NOTICE OF PUBLIC HEARING
Minor Variance

| APPLICATION NO.: | A-25:176 | SUBJECT PROPERTY: | 20 Canada Street, Hamilton |

PROJECT
 PROPOSED SEVERANCE AND NEW 3-STORY TRIPLEX
 20 Canada Street
 Hamilton, ON
 L8P 1P2

Re: Zoning District: R1a (Low Density Residential – Small Lot Zone)
Zoning By-law: Hamilton Zoning By-law 05-200
File Number: ZCR-25-124
Address: 20 Canada Street, Hamilton

SHEET TITLE
 SITE PLAN

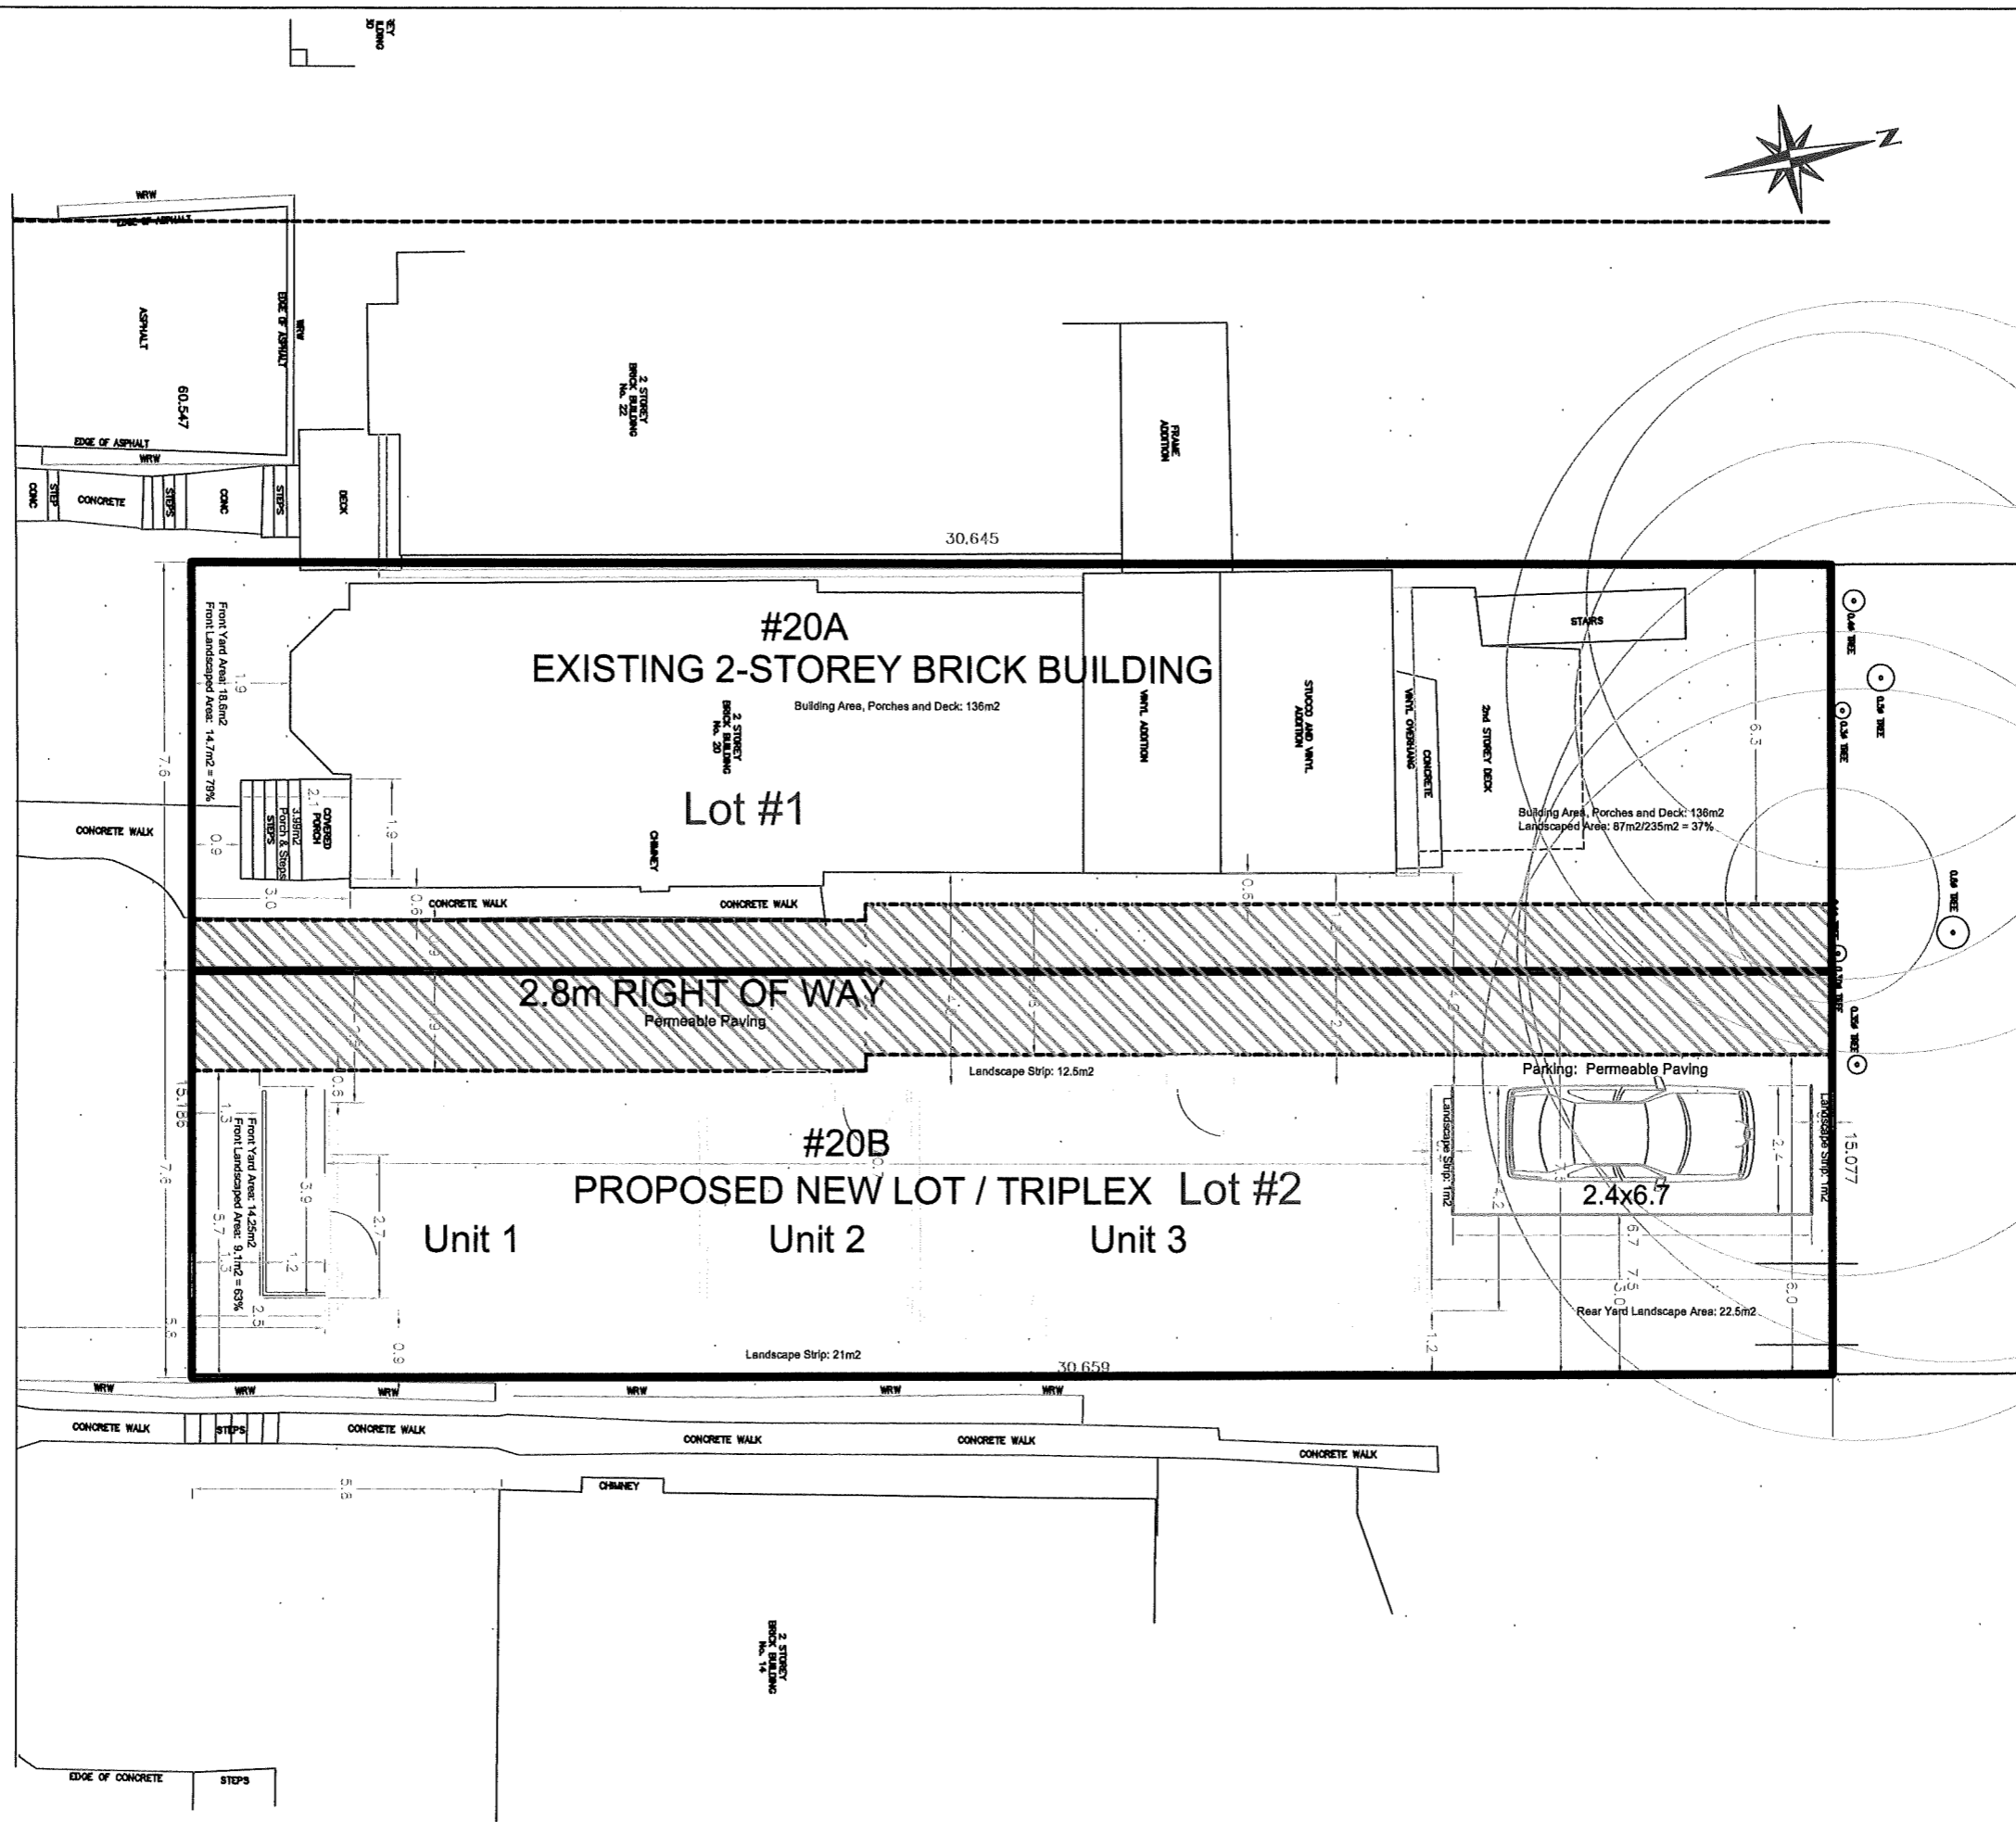
4. The lands to be retained have been identified as '#20A' and the lands to be severed have been identified as '#20B' on the submitted site plan.

For the purpose of this review, the parcel to be retained has been reviewed as **Lot 1** and the parcel to be severed has been reviewed as **Lot 2**.

| | Required By By-Law | Provided | Conforming/ Non-Conforming |
|---|---|--|---|
| Minimum Lot Area As per Section 15.2.2.1 a) of Hamilton Zoning By-law 05-200 | Triplex Dwelling - 270.0m ² | <u>Lot 1</u> 228m ² <u>Lot 2</u> 235m ² | Non-Conforming Minor Variance Required |
| Minimum Lot Width As per Section 15.2.2.1 b) of Hamilton Zoning By-law 05-200 | 9.0 metres | <u>Lot 1</u> 7.6m <u>Lot 2</u> 7.6m | Non-Conforming Minor Variance Required |
| | i) Notwithstanding Section 15.2.2.1 c) i), for lots identified on Figure 36 of Schedule "F" – Special Figures of this By-law, a building may be erected closer to the front lot line in accordance with the following: 1. Within 10 percent of the | <u>Lot 1</u> 1.9m <u>Lot 2</u> 2.5m | Non-Conforming Minor Variance Required |

| | Required By By-Law | Provided | Conforming/ Non-Conforming |
|--|---|---|--|
| Minimum Setback from a Side Lot Line As per Section 15.2.2.1 d) of Hamilton Zoning By-law 05-200 | 1.2 metres | <u>Lot 1</u> 1.5m (east) <u>Lot 2</u> 2.1m (west) 0.9m (east) | Non-Conforming Minor Variance Required for the setback abutting No.14 |

| | Required By By-Law | Provided | Conforming/ Non-Conforming |
|--|---|---|---|
| | d) A porch, deck or canopy may encroach into any required yard to a maximum of 1.5 metres, or to a maximum of half the distance of the required yard, whichever is the lesser; <i>The required front yard is 3.4m, the building itself encroaches into the required front yard 0.9 metres.</i> | <u>Lot 2</u> The front porch encroaches into the required front. | Non-Conforming Minor Variance Required |

| | Required By By-Law | Provided | Conforming/ Non-Conforming |
|--|--|---|-------------------------------|
| c) A single area within the required landscaped area for tree protection and/or tree planting, subject to the following: i) each side shall be a minimum 3.75 metres in length; and, ii) shall not contain hard landscaping or structures. | Landscaped area for tree protection and/or tree planting has not been identified on the submitted plans | Non-Conforming Minor Variance Required | |

| | Required By By-Law | Provided | Conforming/ Non-Conforming |
|---|---|---|-------------------------------|
| | <p>b) Minimum Access Driveway Width</p> <p>The width of any driveway providing access to a parking space shall be a minimum of 2.7 metres</p> | <p>Access driveway measures 2.8m in width.</p> | <p>Conforming</p> |
